# Dennistoun Community Council

## Dennistoun Community Council 2025 Engagement with Glasgow City Council Regarding Proposals for Road Safety, Traffic and Parking Control Measures

Covering the period from March to December 2025

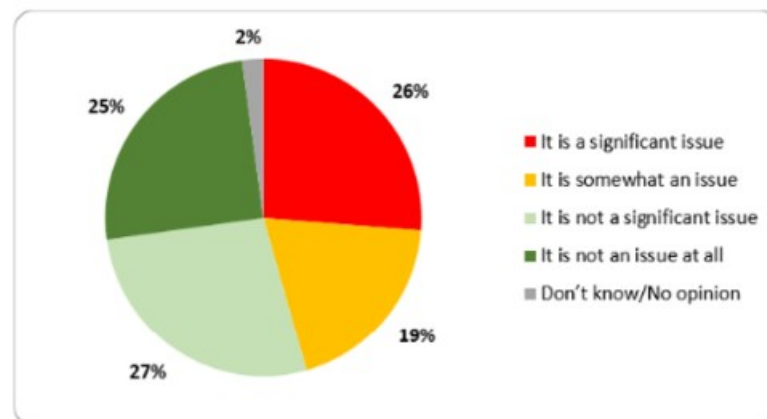
1. **DCC comment: Removing vehicular through-route and short-cut routes along residential streets, between main roads such as Duke Street and Alexandra Parade, would calm traffic. But there are no proposals for preventing these vehicular movements. The selection of one way streets being proposed will not prevent through-traffic. Indeed, it will still be possible to drive in a direct straight line along Armadale Street, from Duke Street to Alexandra Parade. One-way streets, alone, cannot be expected to adequately control through-traffic, and will largely just end up diverting vehicles along different streets. Physical restrictions and/or modal filters are required. Sword Street/Reidvale Street is an illustration of how this type of restriction has been implemented locally.**

- DCC requests GCC consider for this for the final proposal.
2. **DCC comment: It looks as if proposed parking bays encroach into the extent of existing double yellows in a number of locations. If that is the case, this is concerning in terms of visibility splays for pedestrians, etc. Request GCC Clarify in final proposal.**

- 3. **DCC comment: No measures are shown that would provide step-free access along key through-routes of pedestrian travel which currently have very poor levels of provision in that regard, such as Onslow Drive, Craigpark and Eastercraigs. Would make the area much more navigable for people in a wheelchair, or with a buggy/pushchair. Request GCC clarify in final proposal.**

- 4. **DCC comment: One way streets without contraflow cycling create unnecessarily extended and diversionary routes for cycle users. Most residential roads within the area are currently in operation as two-way streets, but in reality only have sufficient width available for one vehicle at a time in either direction. But it's nonetheless acceptable for them to operate with vehicles and cycles able to travel in opposite directions. If converted to properly signed 20 mph one-way streets for vehicles with contraflow cycling permitted, these same residential streets would retain the same geometry and same levels of safety. This contraflow arrangement was proposed and installed on various streets as part of the 2020 'Spaces for People' measures. The cycling contraflows were then subsequently removed without any clear justification being provided.**

- 5. **DCC comment: Effective round-the-clock enforcement of existing double yellow markings, pavement parking restrictions, and severely overgrown vegetation would go a long way toward making the area more accessible for pedestrians. But if GCC has determined that a controlled/restricted parking zone is the only way to ensure safe parking, the rationale for that, and the proposed parking fees and their structure requires to be clearly explained.**

- *GCC response: Difficult to find a solution for everyone in this instance. Previous proposals to prevent short cuts have been objected to by residents of the streets in question as this impacts their journeys too. Could potentially look at additional traffic calming like more speed bumps. Reluctant to block access due the impact this has on residents but can consider it if we want to push for it. However should be noted that generally people always find alternatives or will simply push more traffic through narrower streets. Additional consultation required if this is to be pursued.*

- GCC response: *The ends of the existing double yellows will be used as the markers for the start of any marked parking bays. In general where RPZs are created there is also no need for double yellow markers and consideration for crossings and visibility is taken into account. Mixture of double yellows and no yellows where the RPZ is in place and also depends on the street itself. For example a one way might be 5m from the end of the road to the start of the first parking bay before, a two way could be up to 10m it also depends on the existing markings.*

- GCC response: *Dropped kerbs and tactiles will be part of the build outs, e.g. Onslow Drive and around the schools. Would need a different plan for additional dropped kerbs if these are to be requested. The plan will be updated to show the dropped kerbs and tactiles. Regarding impact assessments they are not aware of one for the liveable*

- GCC response: *Police asked to remove the cycle contraflow on safety grounds and risks involved. This would need further assessment and need to be raised with road safety and police if we wanted to pursue this. Removal of one ways would further reduce spaces to create a passing place for example.*
